## RPRC RETURN LETTER

Application Number: 2022-0602

Street Location: 5 SHIPPEN RD

Re: RPRC Return Letter, dated August 2, 2022  
5 Shippen Rd  
Application No. 2022-0602

SHEET # **SW-101**

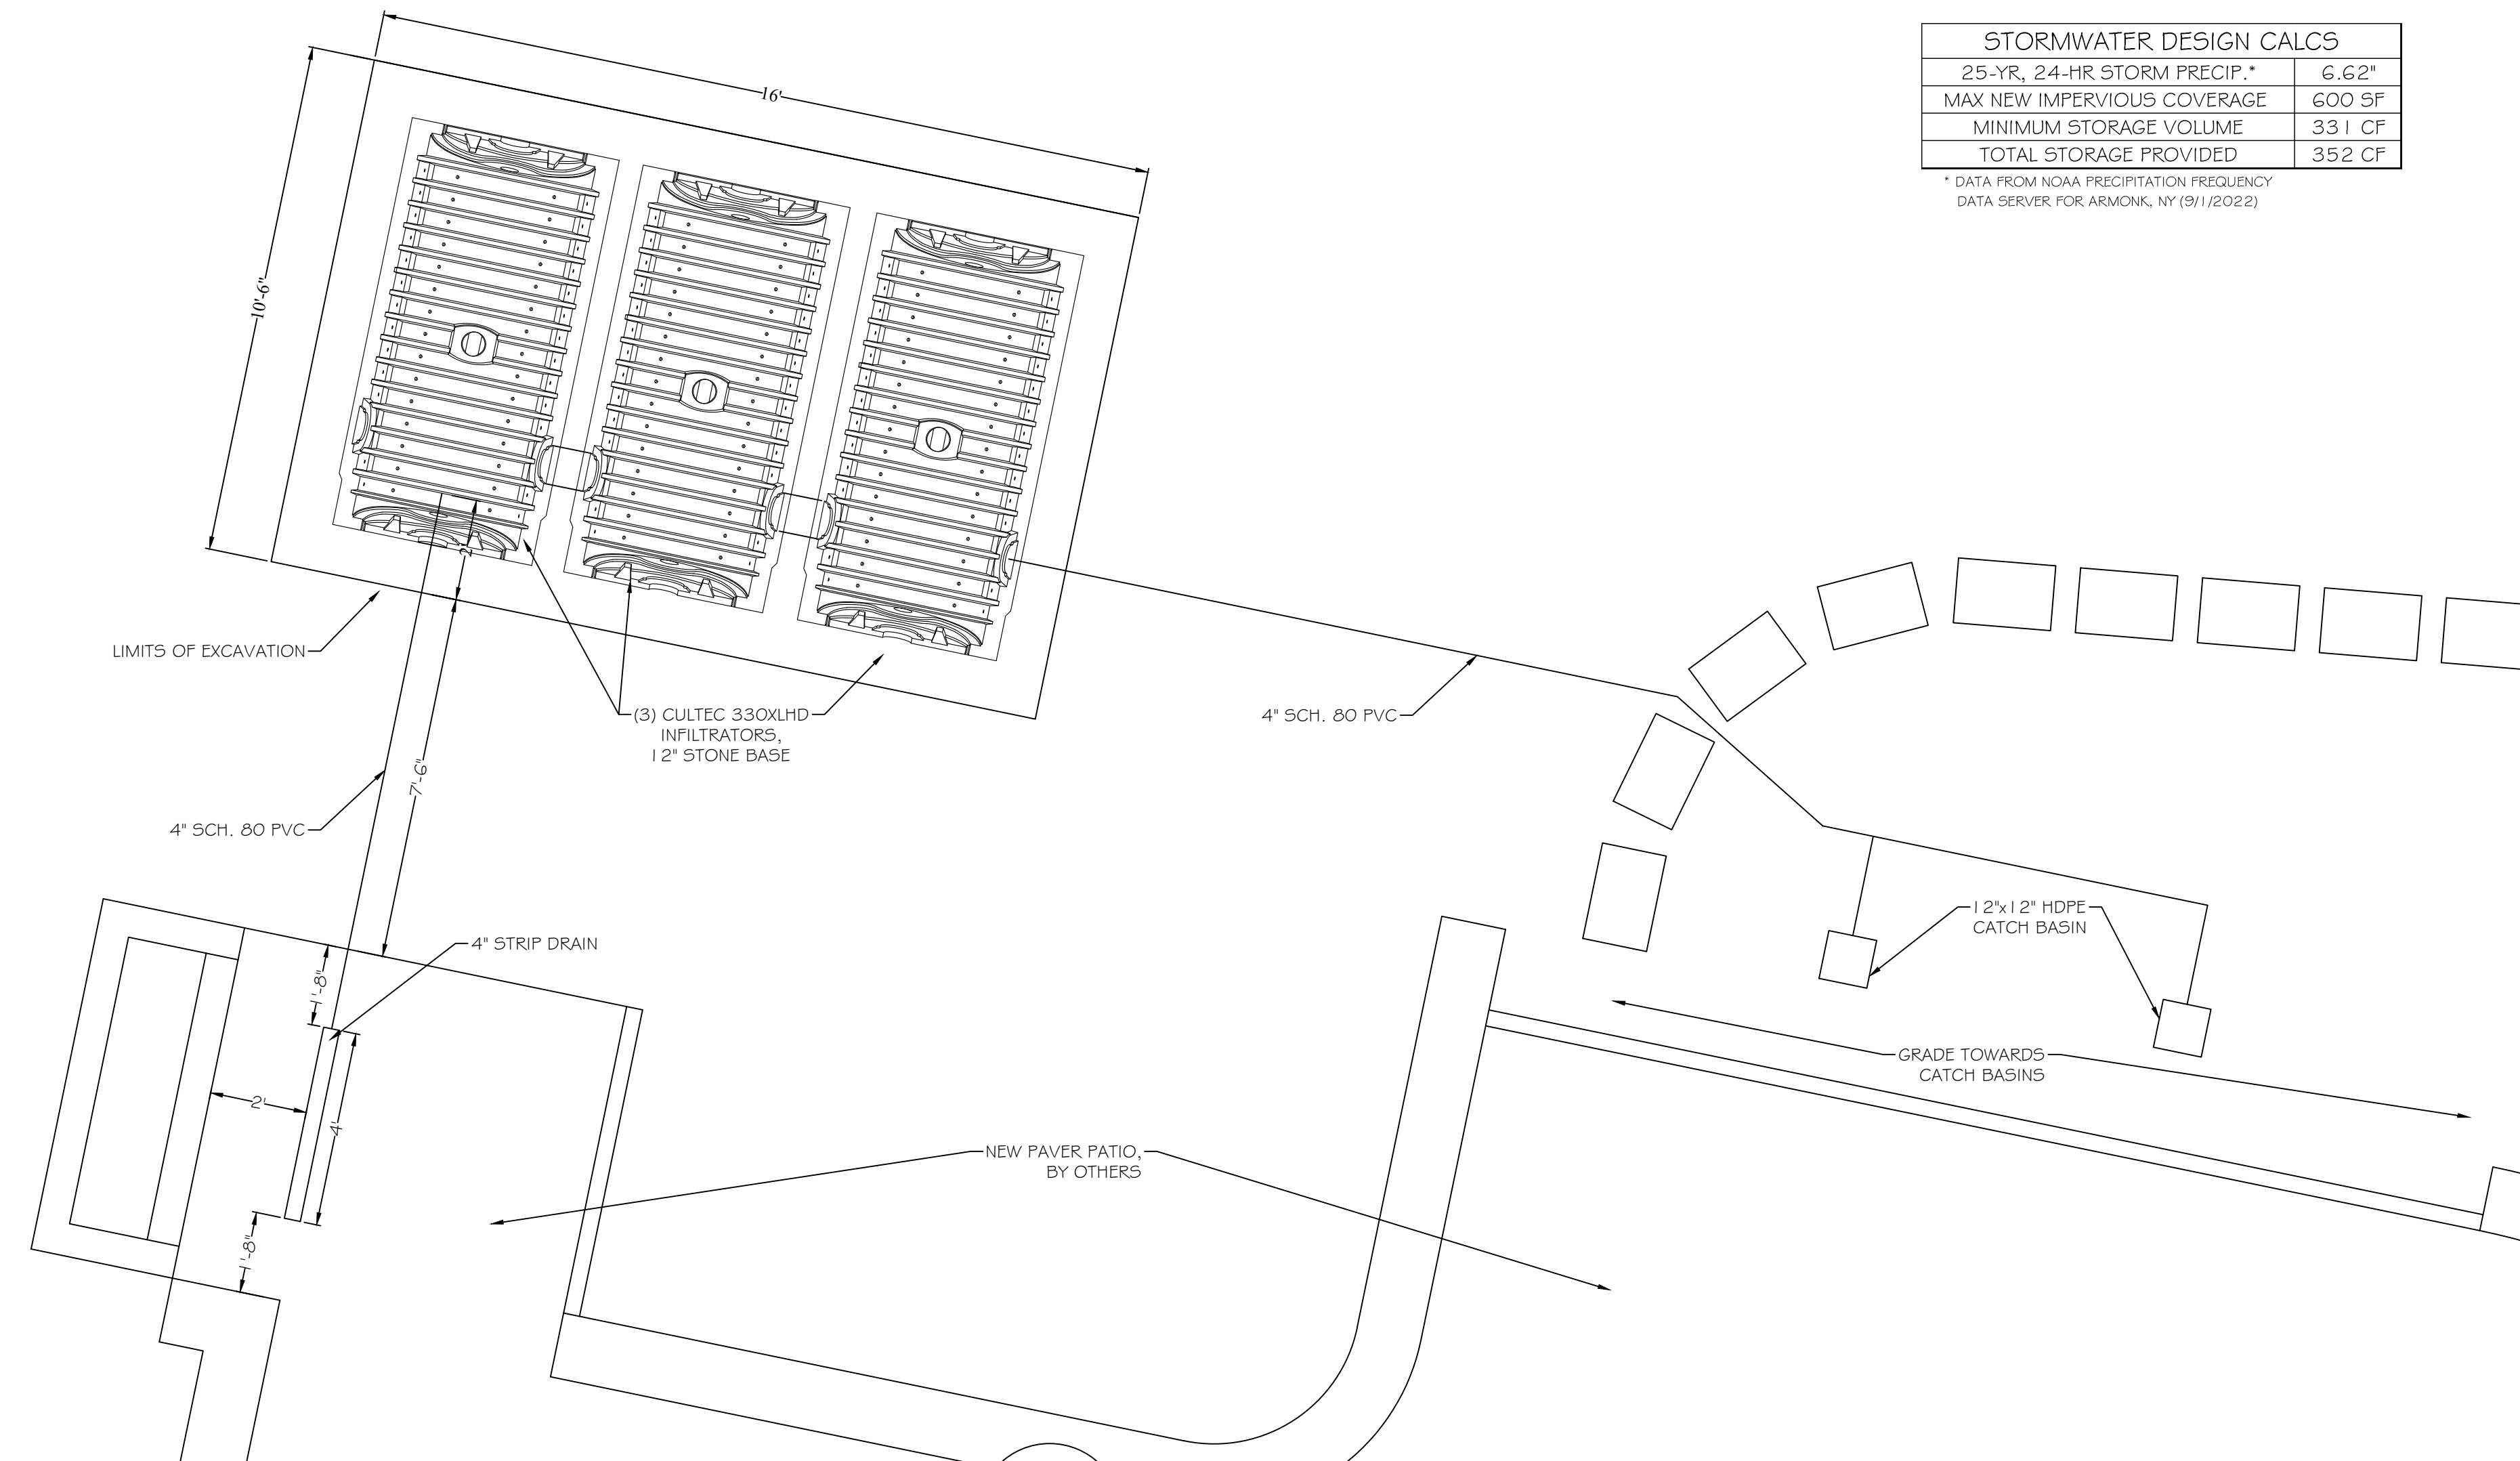
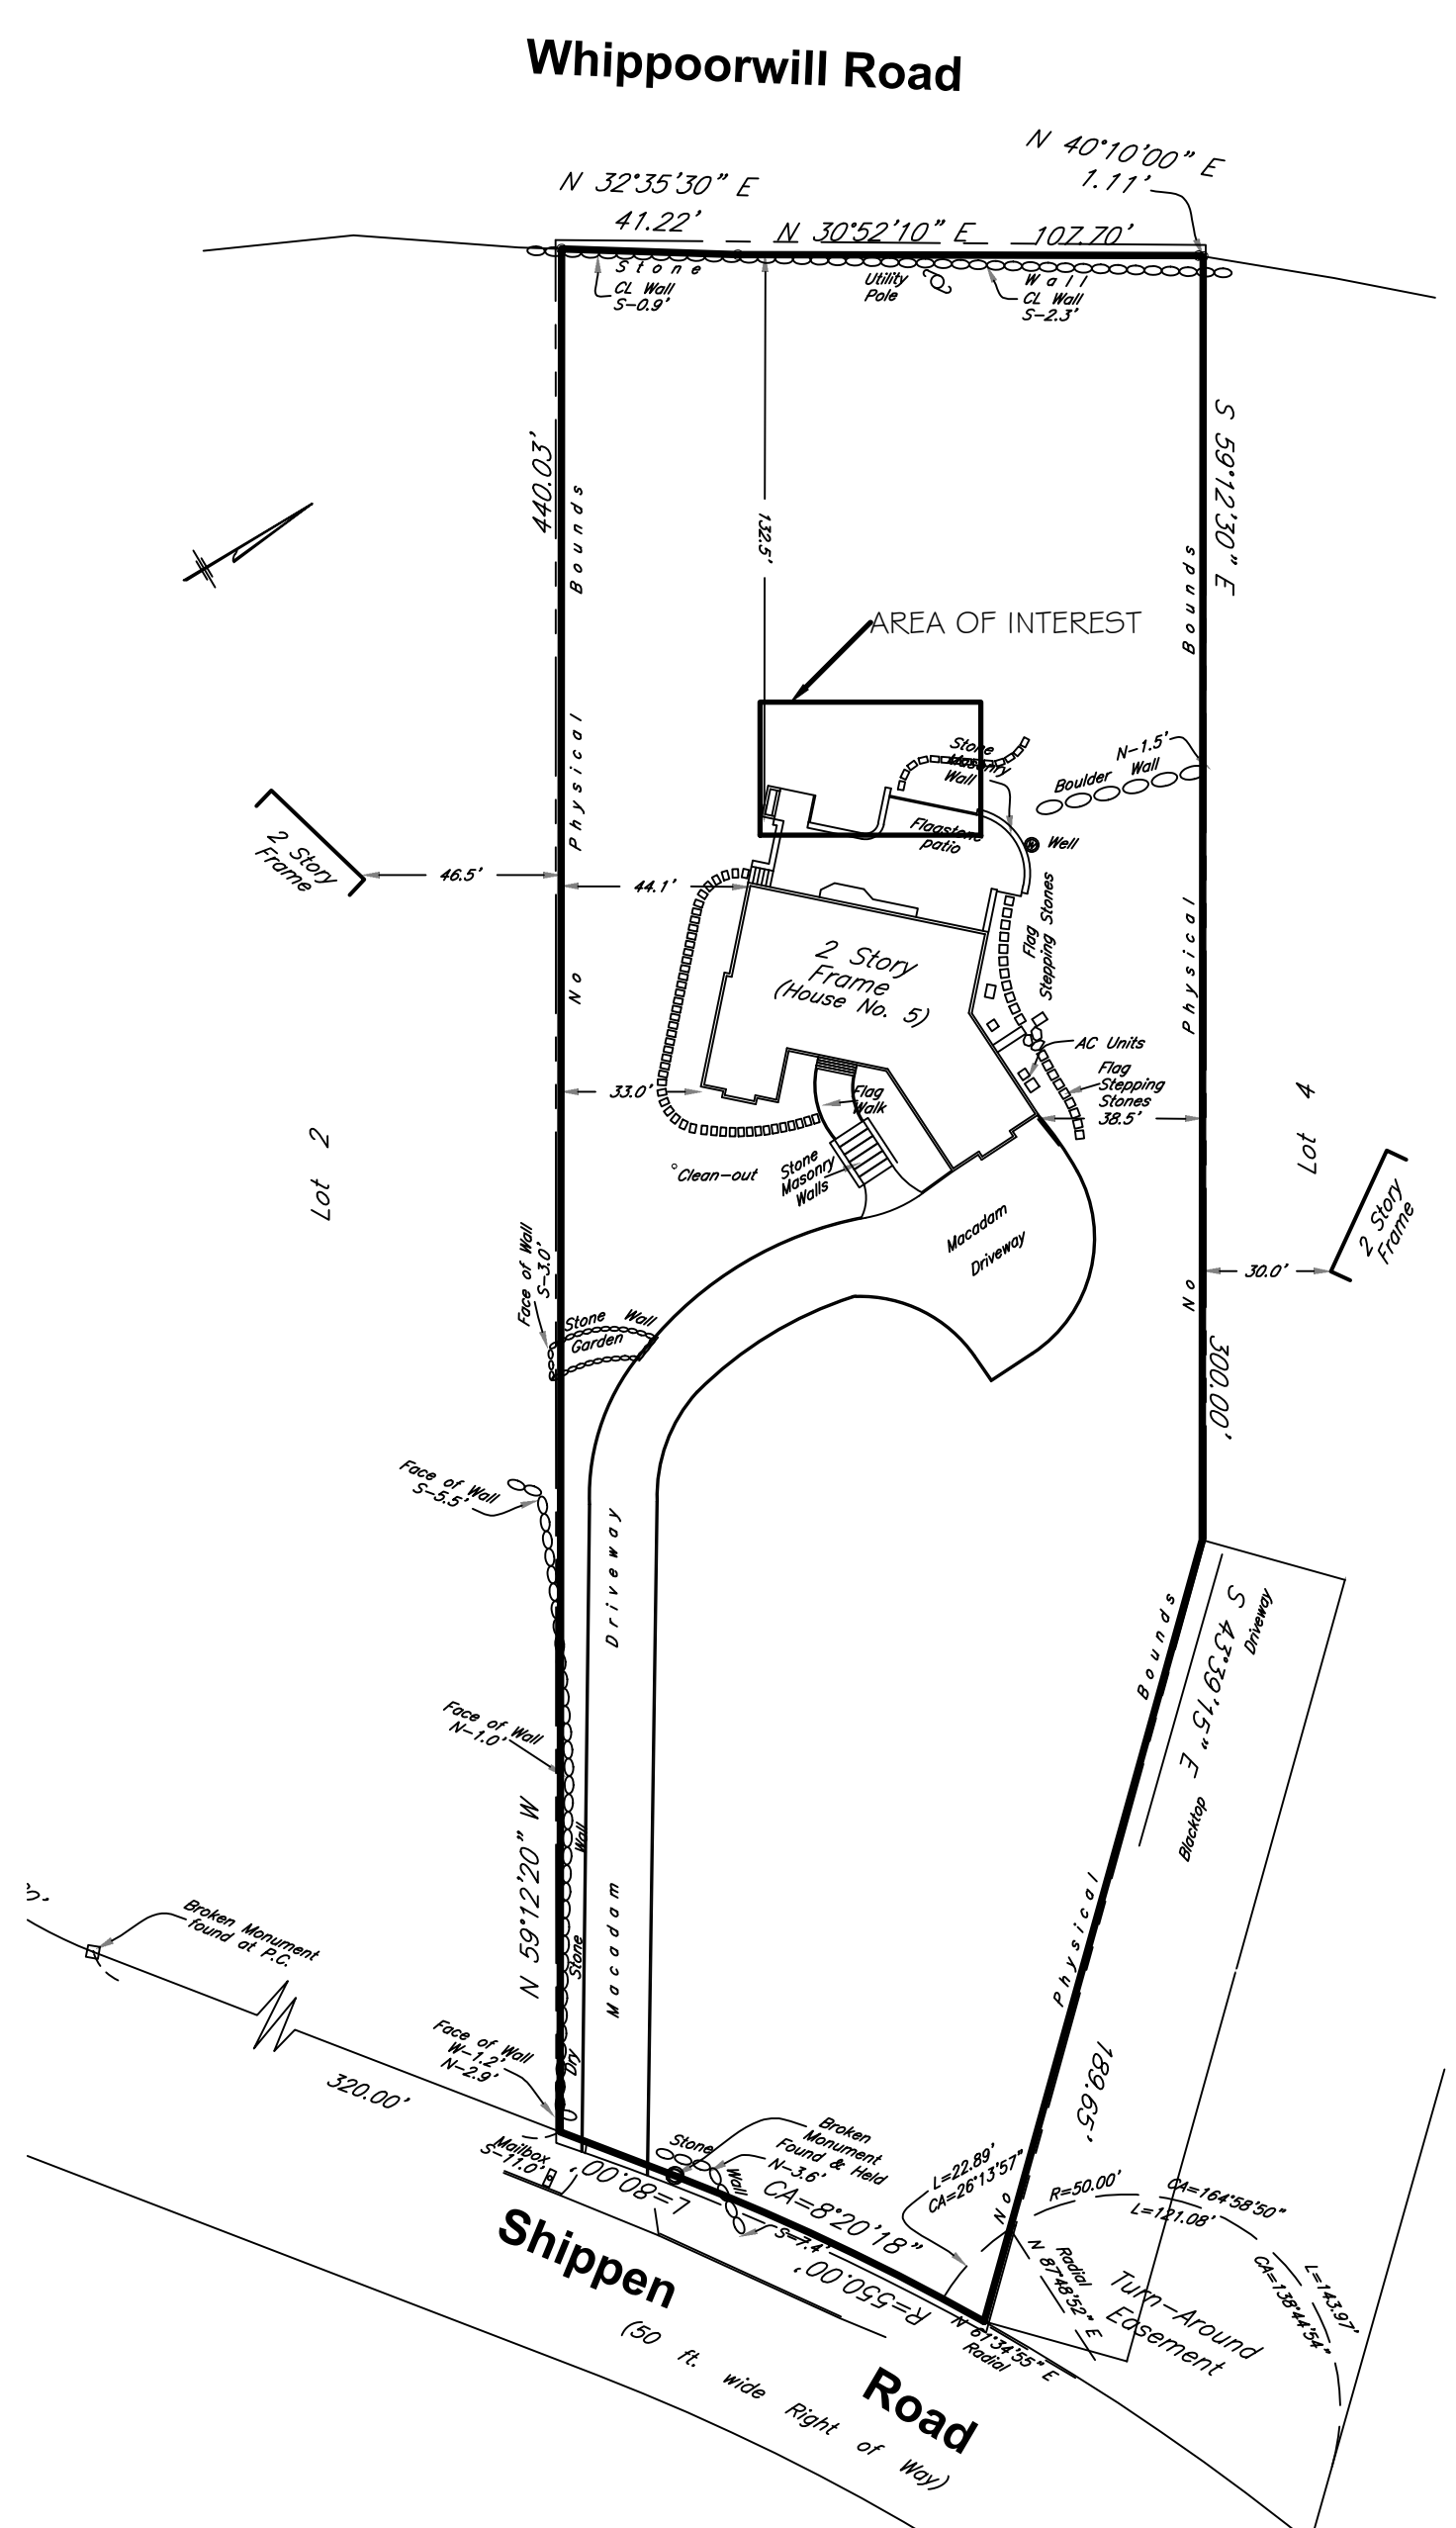
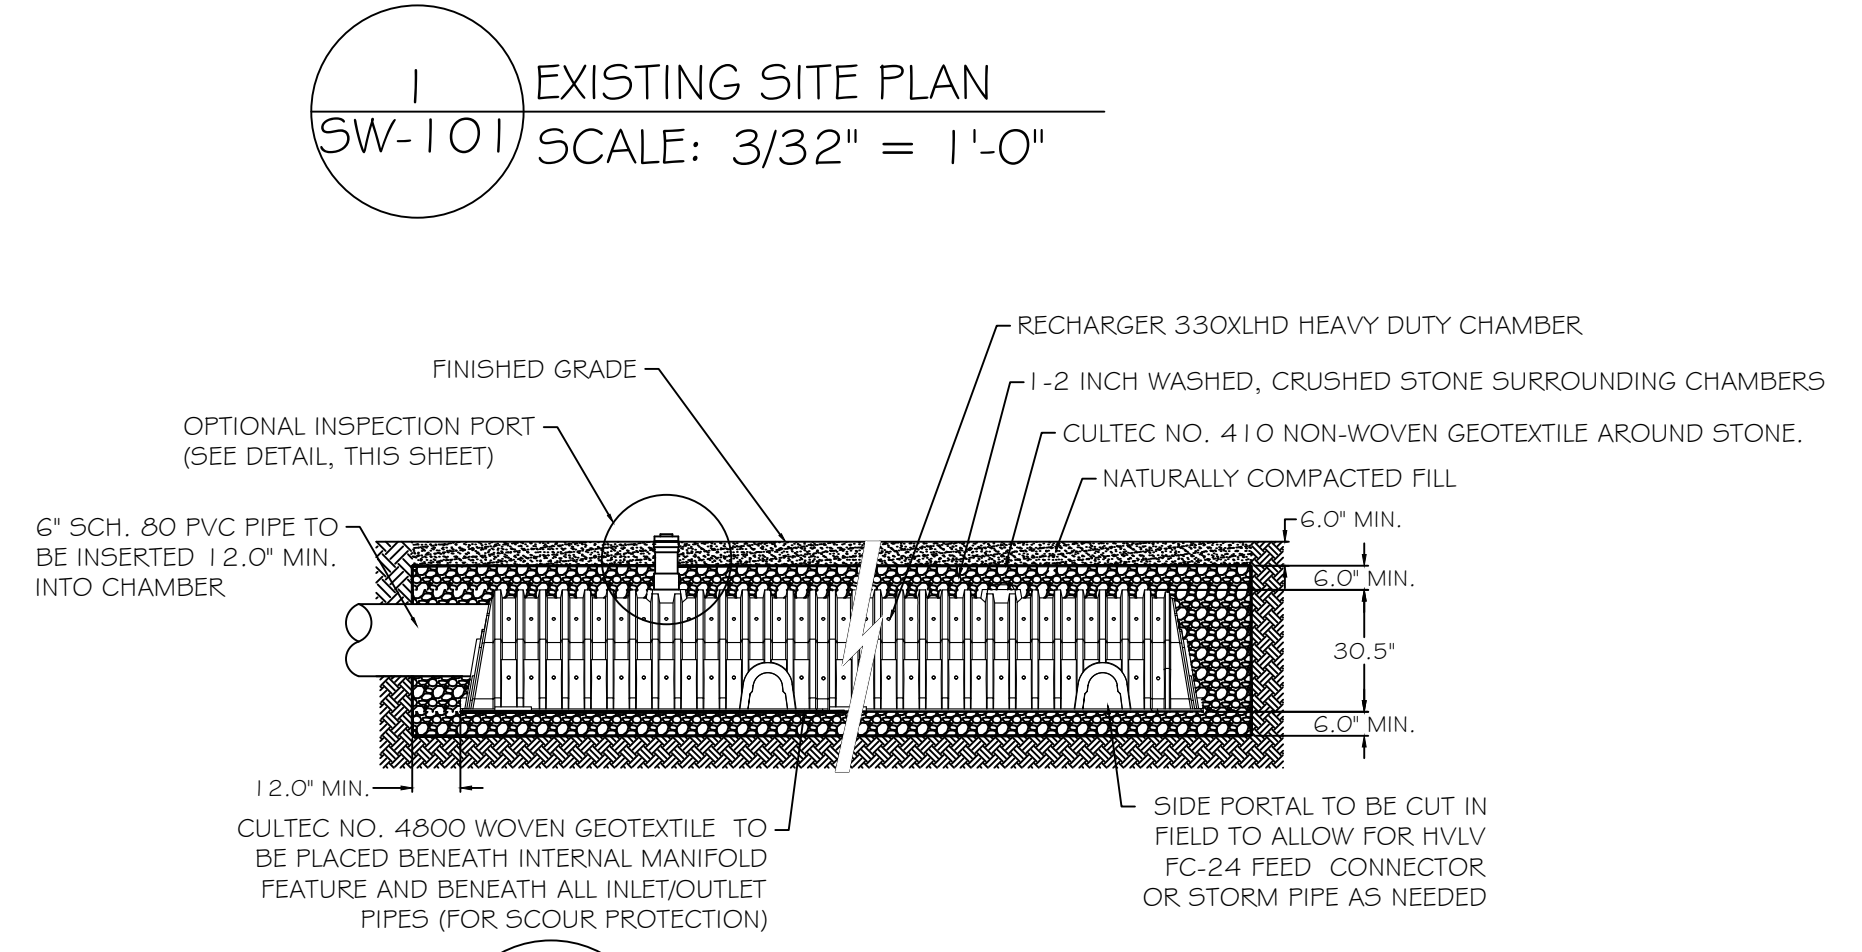
- Provide stormwater mitigation and design calculations for the runoff generated by the net increase in impervious surface for the 25-year, 24-hour design storm event. Provide details of the stormwater mitigation system.

- The plan shall illustrate the drainage pipe connections on the site plan. Include the size, slope and material.
- Include erosion control measures on the plan, including, but not limited to, temporary silt fence, etc.

- A copy of the Gross Land Coverage Calculations Worksheet has been submitted.
- Per conversations with the Town Engineer, the design capacity for the stormwater infiltrators was calculated to store the 25-year, 24-hour design storm event without reductions for infiltration/percolation into the in-situ soils. A three-foot over-excavation in the location of the infiltrators will be performed in the presence of the Town Engineer to ensure groundwater is not encountered.

- Stormwater volume calculations are provided on drawing SW-101.
- Drainage pipe information is indicated on drawings SW-101 and SW-102.
- Erosion control measures are shown on drawings S.01, SW-101 and SW-102.
